Summary of Additional Comments Received after Publishing Planning Commission Hearing Notice on June 6, 2018							
Count	Comment Source	Comment Date	Address/Location Referenced	Associated Phase I River Reach	Comment Summary	Date of Response	Boulder County Response Summary
1	Comment Form	6/6/2018	1177 Fourmile Canyon Drive	Fourmile Creek	See included PDF of compiled emails & letters (6/6/18 to 7/23/18)	6/12/2018	See included PDF of compiled emails & letters (6/6/18 to 7/23/18)
2	Email	6/6/2018	6472 Robin Drive	Left Hand Creek	See included PDF of compiled emails & letters (6/6/18 to 7/23/18)	6/8/2018	See included PDF of compiled emails & letters (6/6/18 to 7/23/18)
3	Email	6/12/2018	8725 Streamcrest Drive	Left Hand Creek	See included PDF of compiled emails & letters (6/6/18 to 7/23/18)	6/13/2018	See included PDF of compiled emails & letters (6/6/18 to 7/23/18)
4	Email	6/13/2018	778 Wagonwheel Gap Road	Left Hand Creek	See included PDF of compiled emails & letters (6/6/18 to 7/23/18)	6/13/2018	See included PDF of compiled emails & letters (6/6/18 to 7/23/18)

Exhibit E - Summary of Additional Comments Received after Publishing Planning Commission Hearing Notice on June 6, 2018

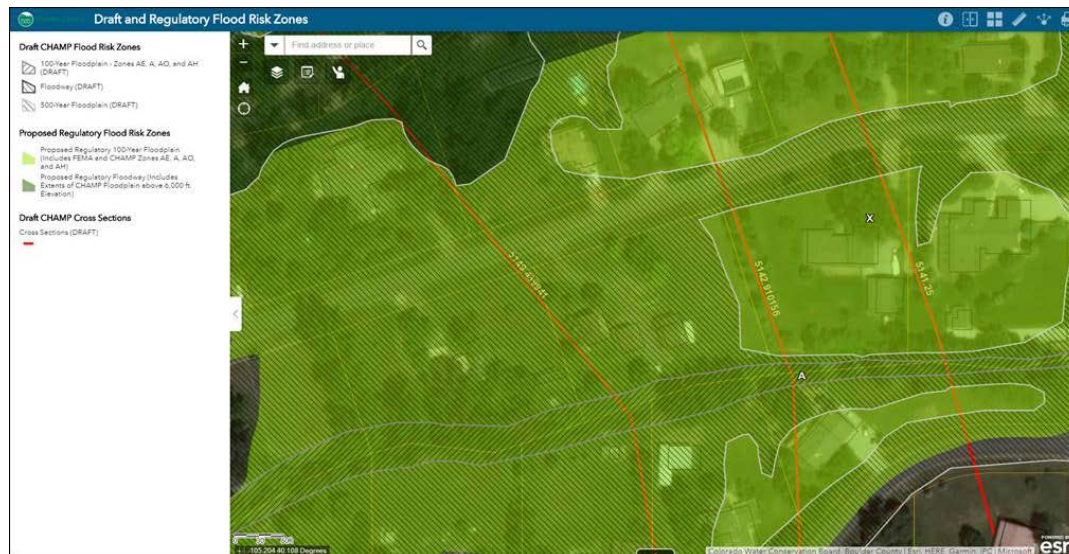
Let's start with the Base Flood Elevation (BFE) value that raised some confusion when you looked at your plans versus the online webmap. The BFE in your house plans submitted for SPR was calculated for the upstream corner of your house, and as a result is not the same BFE measurement as that taken at the upstream cross section to the west of your house. The different values represent different locations.

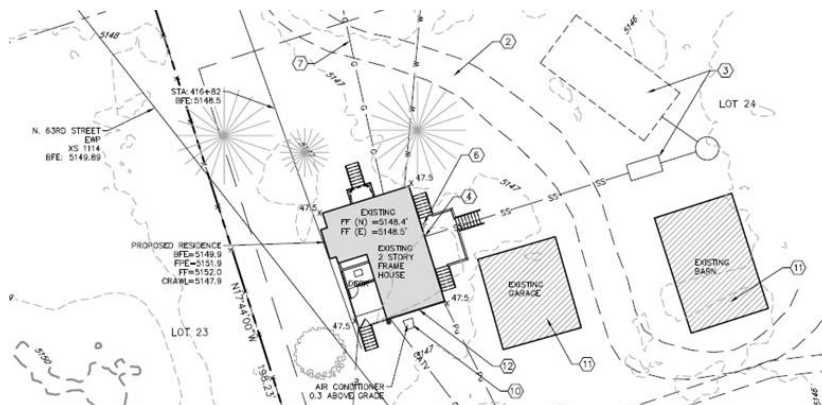
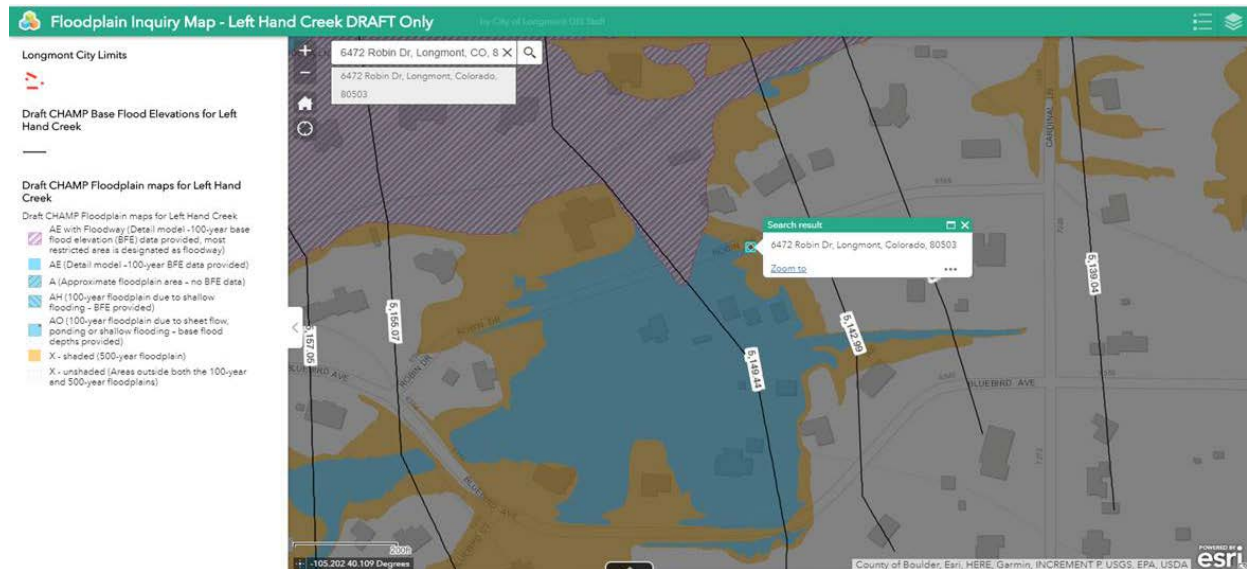
I'd have to check that. The higher BFE was given to me based on the as-built EWP model. The online CHAMP BFE could be showing the older design model. Or it could have been updated to something lower that I don't have. The CHAMP is still a work in progress. So unfortunately things are still in a state of flux.

The draft CHAMP indicates the BFE just west of my house as 5149.44'. This same BFE (noted as XS 1114 in the plans) is stated as 5,149.89'. Which is correct? The draft CHAMP indicates a LOWER BFE than what is shown on my plans. Is the draft CHAMP incorrect?

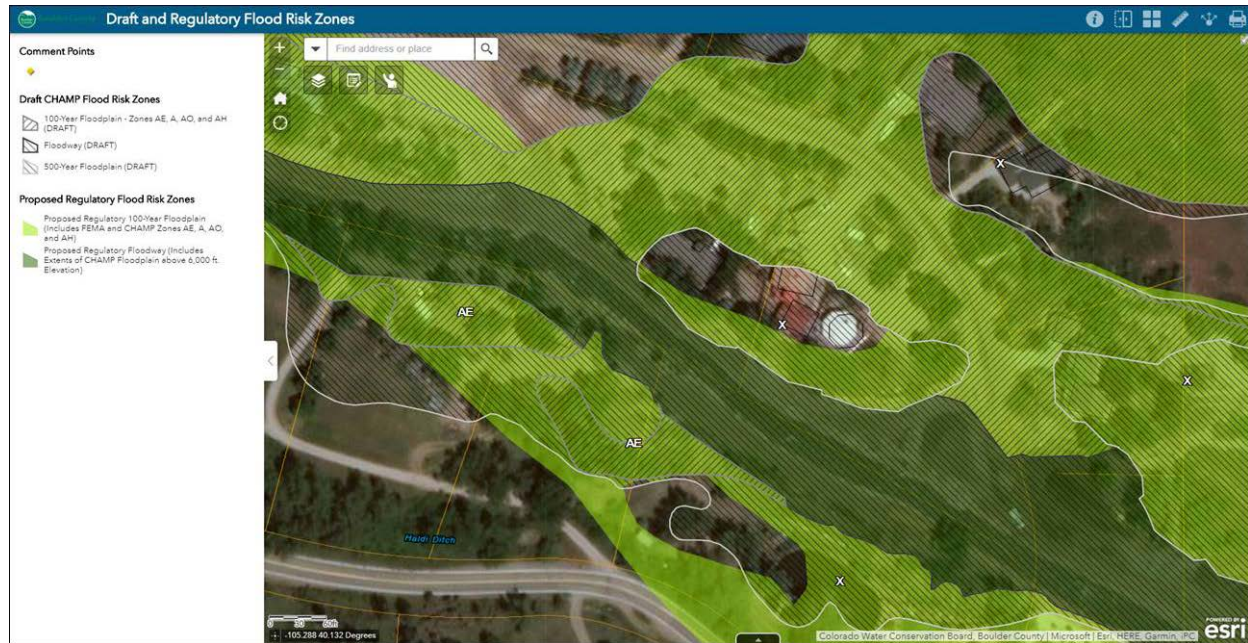
I wanted to let you know that the review of survey data used in the floodplain modeling at your property is complete. The CHAMP engineers and our consultant, with whom you met at the April 12 public meeting, have agreed to disregard the survey point at cross section 71419 where you saw a mapped low spot that seemed incorrect. By disregarding this survey point and elevating the terrain according to photogrammetric survey at this location, there is now a connected island reflected in the mapping in correlation with on-the-ground conditions.

The current maps available online reflect this change – I've included a screen shot here for you:

Figure 21. Fourmile Creek at Logan Mill on September 22, 2013. View is upstream from cross section 2 (XS2, table 17).

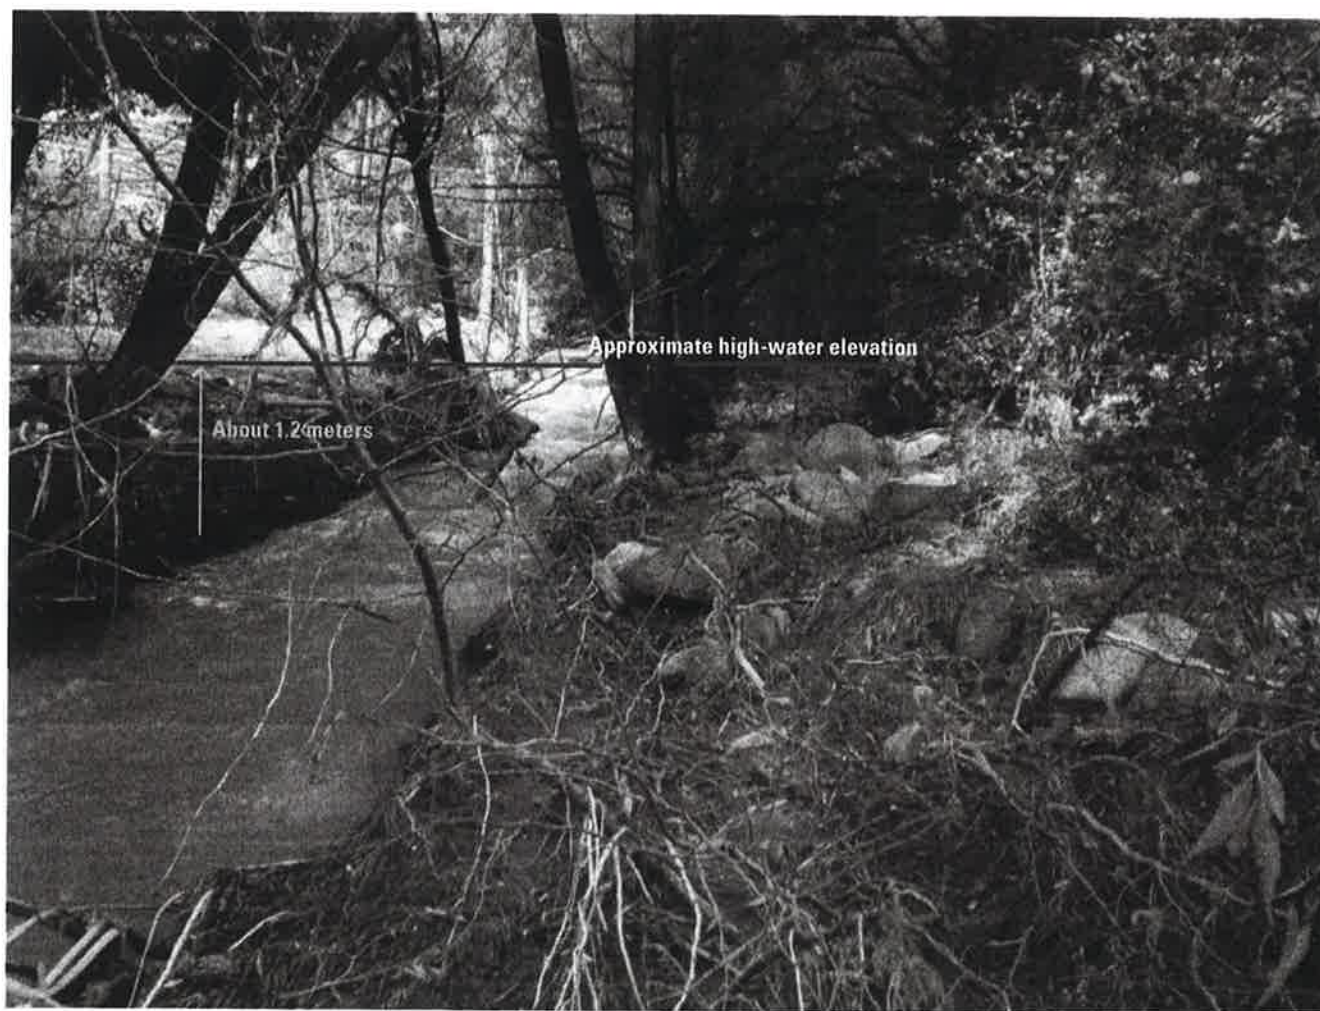
The indirect peak discharge ($67 \text{ m}^3 \text{ s}^{-1}$, tables 1 and 17) was measured on September 22, 2013. This site had a narrow (1–2 m) flood plain along the left bank with trees and bushes, a wider (3–8 m) flood plain along the right bank covered with grass, and a main channel at low flow that was 6–7 m wide (fig. 21). For the Cowan and SA methods, Manning's n was equal to $0.060 \text{ m}^{-1/3} \text{ s}$ for the left-bank flood plain, $0.043 \text{ m}^{-1/3} \text{ s}$ for the main channel, and $0.050 \text{ m}^{-1/3} \text{ s}$ for the right-bank flood plain (fig. 21). An indirect estimate made by the U.S. Geological Survey Colorado Water Science Center for this site was $58 \text{ m}^3 \text{ s}^{-1} \pm 15$ to 25 percent (R. Kimbrough, written commun.; http://nwis.waterdata.usgs.gov/co/nwis/peak/?site_no=06727410&agency_cd=USGS) and another

estimate of $53 \text{ m}^3 \text{ s}^{-1}$ was made by Ritsch and others (2013) using the flow simulation Hydrologic Engineering Center's River Analysis System (HEC-RAS) model. The lower value estimated by Ritsch and others (2013) reflects the different values of Manning's n ($0.05 \text{ m}^{-1/3} \text{ s}$ for the main channel and $0.08 \text{ m}^{-1/3} \text{ s}$ for the flood plains). The Urban Drainage and Flood Control Districts lists a peak discharge of $65 \text{ m}^3 \text{ s}^{-1}$ for the site Fourmile Creek d/s Poorman Rd upstream from #1267 Fourmile Cr Rd nr Orodell (http://alert5.udfed.org/wp/?page_id=115, accessed August 3, 2015), which is about 2,000 m downstream from Fourmile Creek at Logan Mill. With definite flood plains on both sides, the different indirect methods estimated that 73–86 percent of the flow was conveyed in the main channel with the remainder across the flood plain (fig. 21).

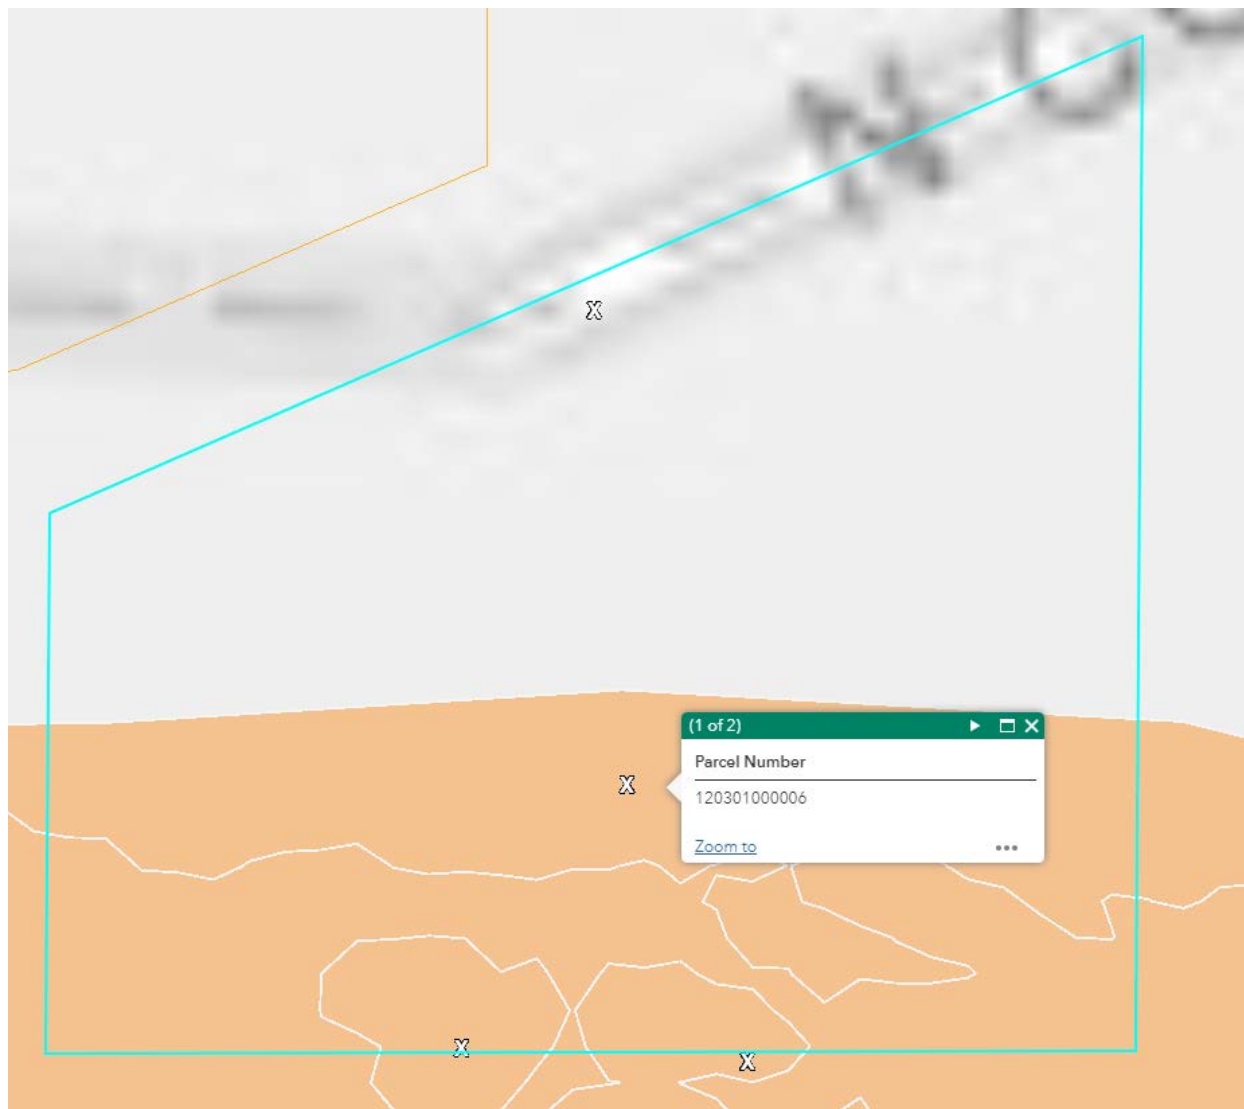
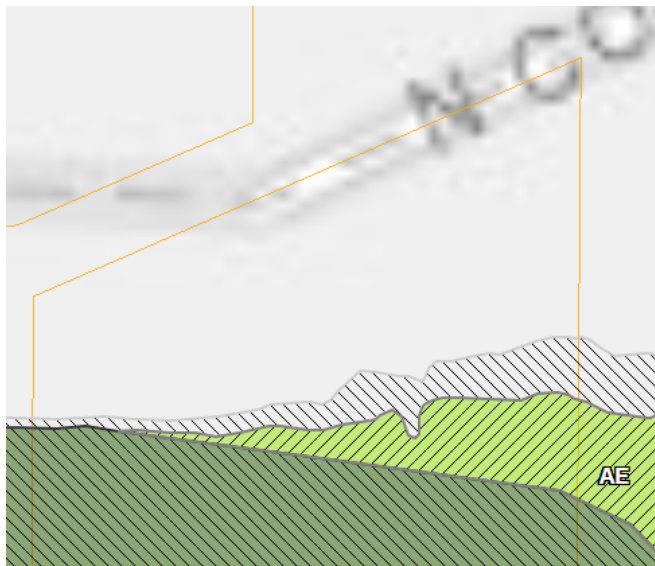
My name is Derena Beard (Tveten) and I have a parcel of land affected by the floodplain re-mapping. By the current map, roughly half of my parcel is covered by the 500 year flood plain (see below).

By the new proposed mapping, my parcel is now roughly half covered by the 100 year flood plain and a third by the floodway.

Could you please help to explain what this means with regards to the potential to build on this parcel?
